SAFETY ORDER

No: SO-P4 091002 1

DOPPELMAYR CTEC SAFETY ALERT BULLETIN SA-08-021 WOLFURT KD08003E

Title: Tower Failure Due to Water Intrusion

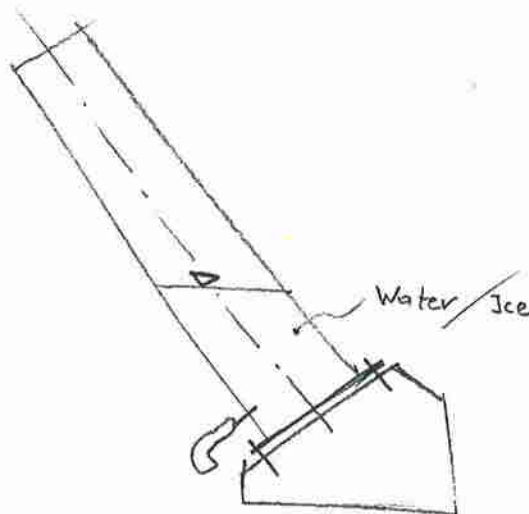
If with a resonance check, water/ice is suspected to be present within the tower but further than 4" (100 mm) from the top plate, a small hole 3/8" - 1/2" (10 - 12 mm) must be drilled near the tower base at the downhill side of the tower along the centerline of the lift 2" to 4" (50 - 100 mm) from the tower base to provide a pathway for water to escape. See illustration below.

3.1.2 Concrete-filled shafts / shaft sections

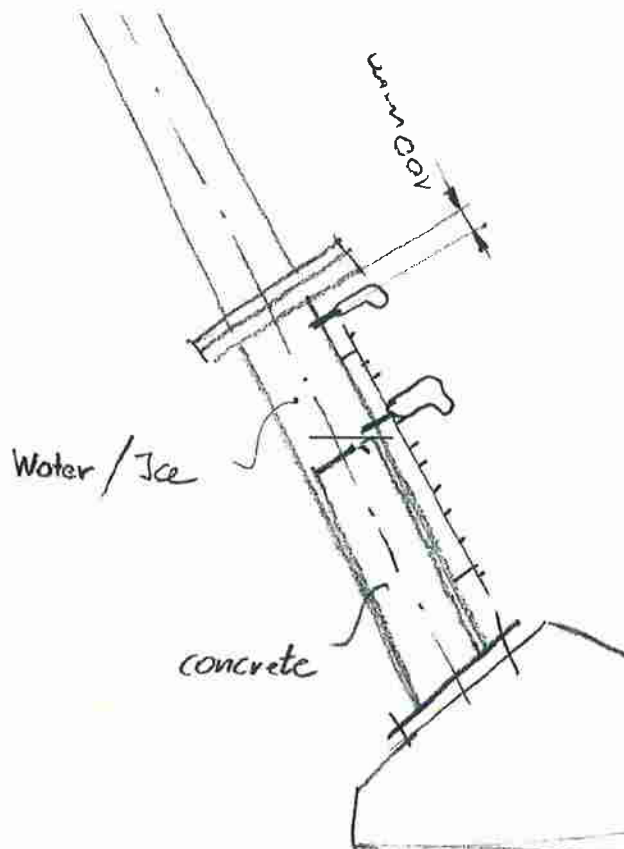
For tower shaft sections partially filled with concrete through the top plate, check the tower section with the hammer method as described previously. If water/ice is suspected, drill a small hole 3/8" - 1/2" (10 - 12 mm) approx. 2 inches (50 mm) below the top plate on the uphill side of the tower (behind the ladder). Tower shafts with a cover for concrete fill on the outside of the shaft already have a drain hole and the cover can be removed for inspection purposes. **If ice is found in this section, this shall be cause for immediate and continued closure of the lift to public transportation** and must be reported to the nearest Doppelmayr representation office for review and recommended repair procedures.

A small drain hole 3/8" - 1/2" (10 - 12 mm) is required to eliminate the water above the concrete level. See illustration below.
